7.1.3 TPA/56395 - 31-33 HIGH STREET ROAD ASHWOOD - DEVELOPMENT AND USE OF A FOUR STOREY MEDICAL CENTRE

EXECUTIVE SUMMARY

This application proposes the development of a four-storey building comprising three storeys above a basement level, for use as a medical centre with a total of 16 specialist practitioners. Two significant trees are proposed to be removed. The proposal also seeks the erection of signage and alteration of access to High Street Road, being located within the Transport Zone Schedule 2

High Street Road Elevation

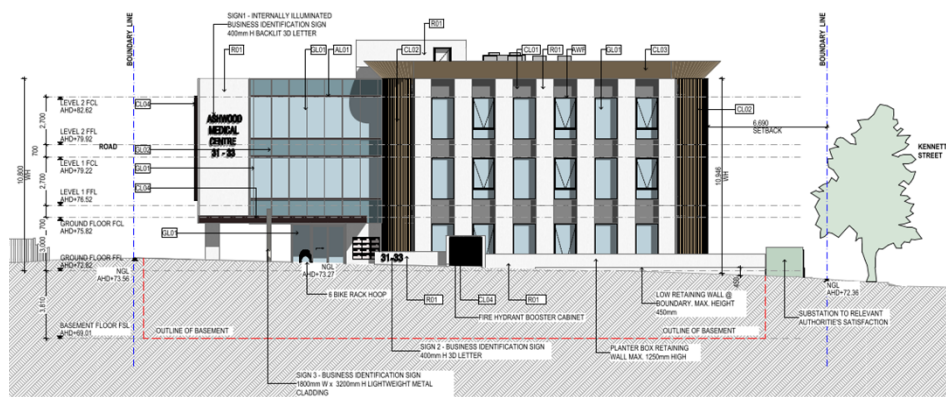
The sheer walls from ground to the roof line provide no relief or transition to the surrounding lower height development, particularly the directly abutting dwellings to the north.

Whilst robust materials are sought in the Scheme, the building's finishes in precast concrete, cement cladding and shiny metal will further exacerbate the dominance of the building in the residential setting. The vertical fenestration and elevated roof expression further accentuates the height.

Basement floorplan

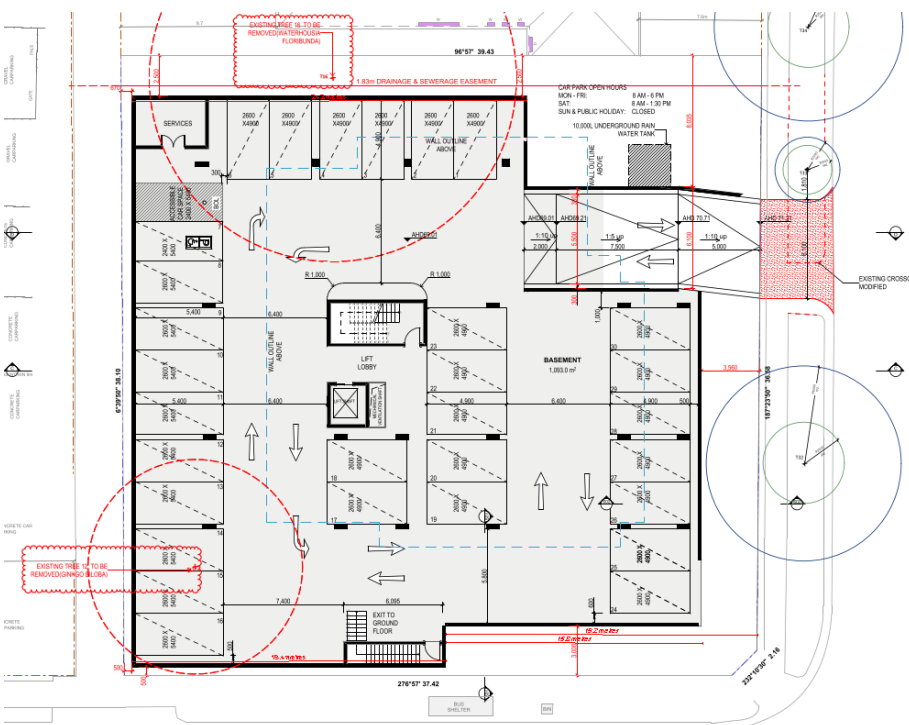
The proposed development meets the front, side and rear setback, and site coverage requirements, however the front fence height is exceeded. There is insufficient garden area and permeable surface, which are often indicators of over-development.

Front setbacks of neighbouring dwellings in High Street Road and Kennett Street are generous, at typically 7.6 metres, or more, and contain landscaped gardens with canopy trees. Although the proposed building setbacks to High Street Road and Kennett Street are 7.6 metres and 6.8 metres respectively, and generally consistent with neighbouring setbacks, there are significant encroachments within them. The basement abuts the boundary in High Street Road for half of the frontage, being setback 3 metres for the remainder of its length. The basement is also only setback 3.56 metres from Kennett Street. On the north it is setback only 2.5 metres for a length of over 24 metres, with the area constrained by the 1.93-metre-wide easement. Also within the northern setback is a 10,000 litre underground water tank. The proposed basement footprint leaves limited deep soil areas for meaningful landscaping to visually soften and buffer the large building from the street of the abutting dwelling.

Above the basement, the provision of feature pedestrian paving, staircase access to the basement, and services such as waste storage, electrical substation and fire hydrant booster further harden the setback impacting on visual amenity.

Eastern elevation plan (Kennett Street frontage)

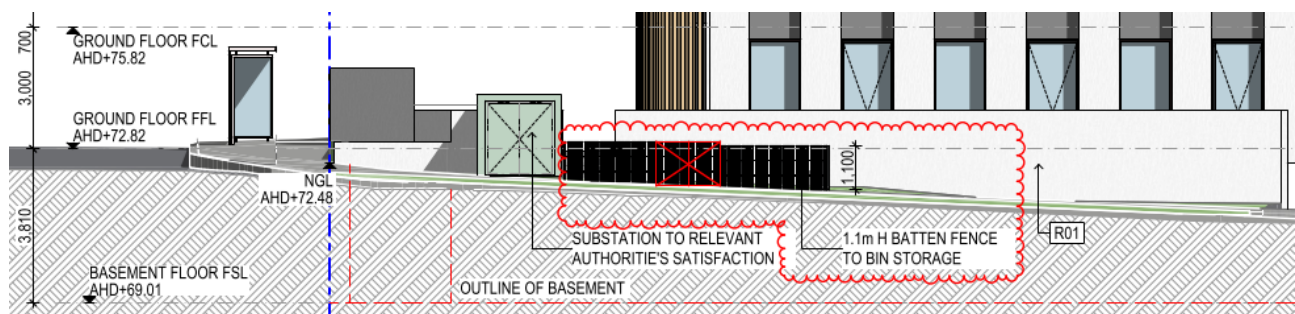
Carparking on the west side of the building, and on the north adjacent to 7 Kennett Street's secluded open space, has also replaced garden planting characteristic of the area.

The carpark will be screened from the street by low plants in a planter (with the soil depth unknown).

The rain garden planted with 500mm high dianella tufting flax is located adjoining the secluded open space area of number 7 Kennett Street, which would benefit from high screen planting, particularly given the loss of the significant tree from that area.

The proposed services, and waste storage area, within the street setbacks will be visually obtrusive, taking up available room for landscaping and cluttering the streetscape. Waste storage should be located within the basement and a more cohesive design provided for the necessary services.

Northern elevation viewed from 7 Kennett Street

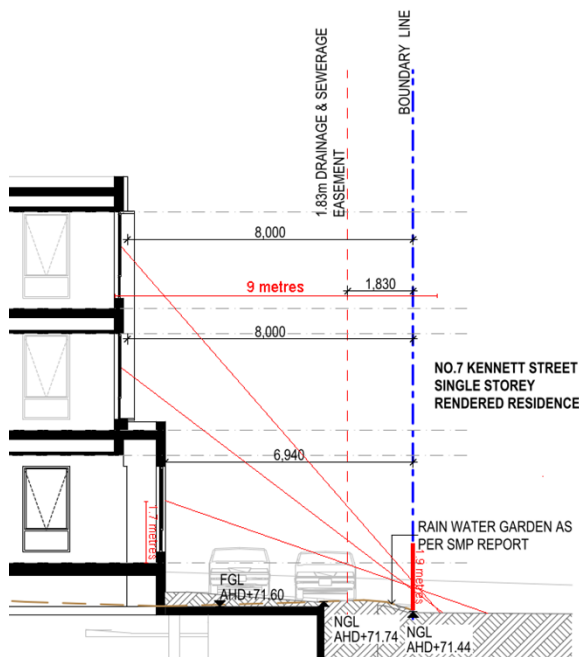
From the neighbouring residential properties, the mass and bulk of the building is excessive and not comfortable in the setting. Whilst the walls are set back a minimum of 5 metres from the northern (rear) boundary, the proposal provides sheer three storey walls on all elevations, reach up to 11.62 metres in the north-east corner. Whilst the northern elevation is broken up by the ground floor and cantilevered elements on the east and west sides, this does little to assist it to integrate appropriately with its residential neighbours.

The report recommends the existing boundary fence be checked for gaps and repaired so noise does not leak into 7 Kennett Street. However, if noise becomes an issue from patrons and their vehicles, construction of a 2.4metre high acoustic fence along the northern boundary is recommended.

West elevation of Sign 3

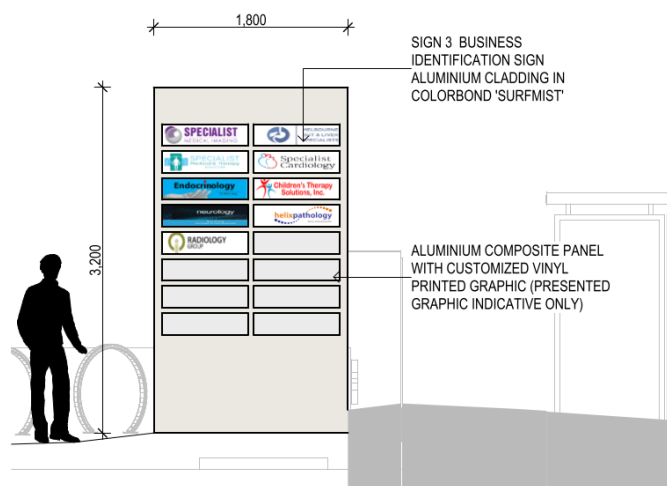
Sign 3 is proposed within the garden planter and will reduce already meagre landscaping opportunity. It will also be 3.2 metres in height, similar to the height of a single-storey wall, which will be another unacceptable intrusion into the setback area. It will also contain detailed information requiring close study from a moving or stationary vehicle in a location where the vehicle would be unprotected from passing traffic. This constitutes a safety hazard.

This sign is not considered sufficiently consistent with the with preferred residential character of the area.
